TECHNICAL SERVICE BULLETIN

Buzz/Vibration/Rattle From Center Left Of Instrument Panel (IP) During Tip-In - Built On Or Before 01-Jun-2023

23-2301
27 September 2023

Ford 2022-2023 Explorer	Built on or before 01-Jun-2023
-----------------------------------	--------------------------------

Figure 1

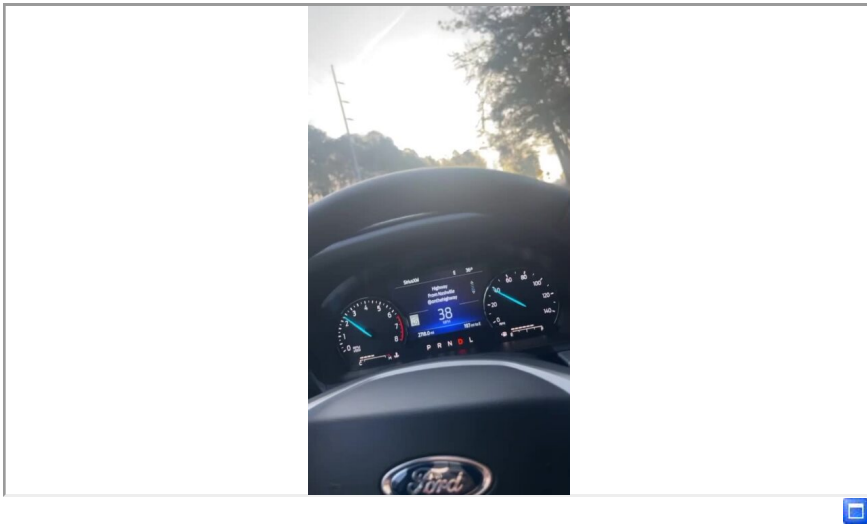
2. Remove the lower steering column trim panel. Refer to WSM, Section 211-04. (Figure 1)

Figure 2

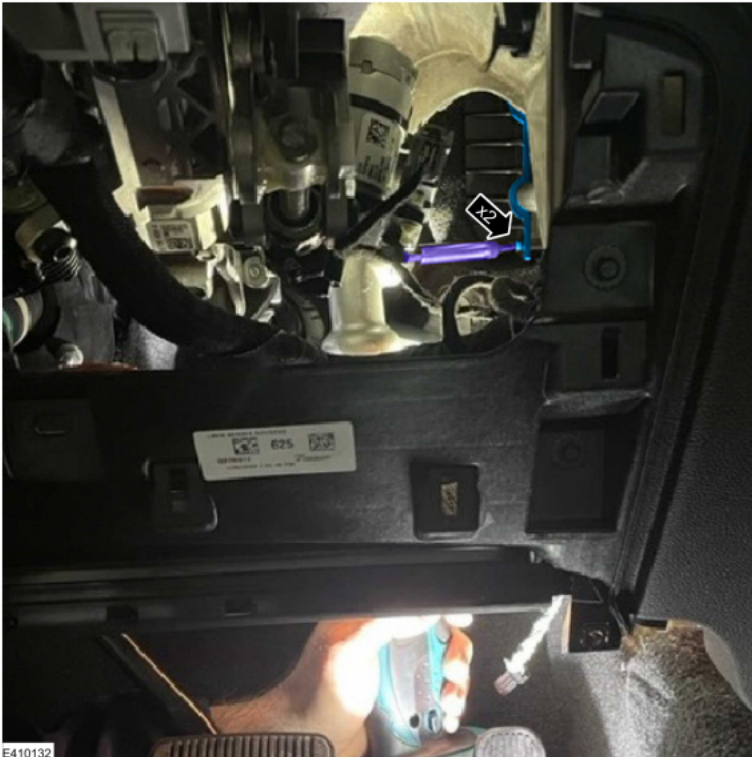
(1). Remove the left half of the heater tube bracket. (Figure 2)
